CNL-16-084

Browns Ferry Nuclear Plant, Units 1, 2, and 3  
Renewed Facility Operating License Nos. DPR-33, DPR-52, and DPR-68  
NRC Docket Nos. 50-259, 50-260, and 50-296

Subject: **Proposed Technical Specifications (TS) Change TS-505 - Request for License Amendments - Extended Power Uprate (EPU) - Supplement 16, Responses to Requests for Additional Information**

**ANP-3487NP, Responses to RAIs for Browns Ferry Nuclear Plant EPU Submittal -  
Nuclear Performance and Code Review Branch**

**Figure 3 Lattice Reactivity Comparison at Same Enrichment**

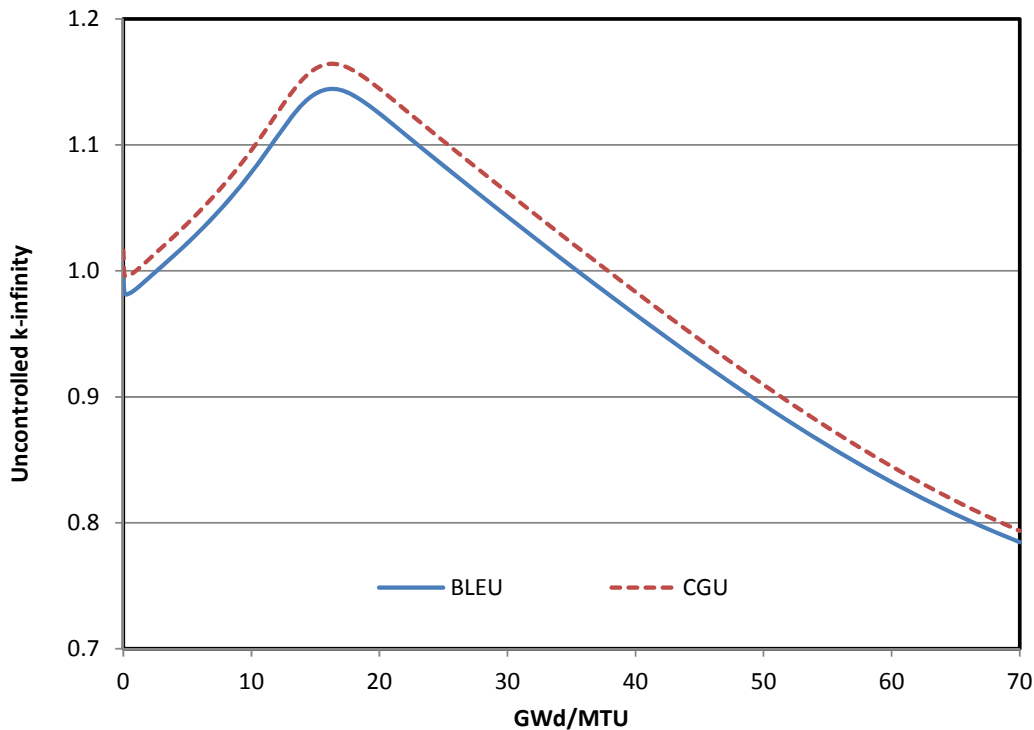
*It is stated in Section 1.0 of ANP-3388P (Reference 10) that “for equilibrium cycle and Cycle 19 of Unit 3, approximately 30 percent of the fuel assemblies in each reload batch are composed of BLEU (blended low enriched uranium).”*

*Is the 30 percent BLEU fuel that will be introduced into Unit 3 for Cycle 19 higher than the BLEU percent for the ATRIUM 10XM fuel transition for the Unit 3 in 2013 LAR? If this percentage is higher than the percentage of BLEU fuel in 2013 fuel transition, what is the impact on the buildup of various uranium isotopes during the depletion of the fuel? Also discuss the impact of the various uranium isotopes on reactivity.*

In the previously approved LAR supporting methodology additions for the ATRIUM 10XM fuel design, the NRC reviewed the continued use of BLEU at BFN. Specifically, in Reference 22 the response to RAI-1 discusses the differences between Commercial Grade Uranium (CGU) and BLEU. The primary discussion points can be summarized as:

- Both CGU and BLEU are subject to the same maximum  $U^{235}$  enrichment of 4.95%.
- There is no difference chemically.
- The isotopes of Uranium have the same electronic signature so substitution of one isotope for another does not constitute a point defect or change the local electronic configuration.
- Thermal conductivity and mechanical properties are not impacted.
- The primary difference is that BLEU has a higher concentration of  $U^{234}$  and  $U^{236}$  isotopes.
- The primary difference in neutronic characteristic is driven by the presence of a higher concentration of  $U^{236}$  which has a neutron poisoning impact. Because the maximum  $U^{235}$  enrichment remains the same, the net impact is reduction in overall reactivity of the fuel.

This reduction in reactivity is illustrated in Figure 3 for lattices with the same enrichment and Gadolinia distributions (i.e., the only difference is the presence of  $U^{234}$  and  $U^{236}$  in the BLEU lattice).
